CSIR- NATIONAL PHYSICAL LABORATORY

Ref No. 14-VIII/SKJ(9-OTE)2024PB/T-77

CORRIGENDUM

With reference to NPL's Global Tender ID: **2024_CSIR_207918_1**, Pre-Bid Conference (PBC) was concluded on 12.11.2024 for "PVTt Standard (Primary Gas Flow Standard)". Consequent upon the outcome of PBC, **some changes have been made in the technical specification of captioned tender. Revised specifications are as follows:**

Figure 1. Schematic diagram of calibration of the laminar flowmeter and sonic nozzle through PVTt Standard (Timer, air compressor system and other automation hardware not shown in the diagram)

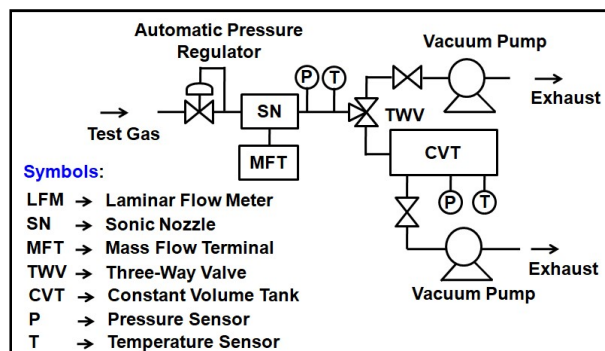
The turnkey PVTt (i.e. Pressure, Volume, Temperature and Time) standard consists of large number of items such as water temperature bath, collection tanks temperature and pressure sensors with indicators, vacuum pumps, vacuum sensors with indicators, sonic nozzles with flow display device, frequency counter/ timer, diverter valves, on/off valves, precision pressure regulators with feedback (also called automatic pressure regulators), pipes and fittings, automation hardware and software etc. Figure 1 shows the schematic diagram of calibration of the laminar flowmeter and sonic nozzle through PVTt Standard respectively.
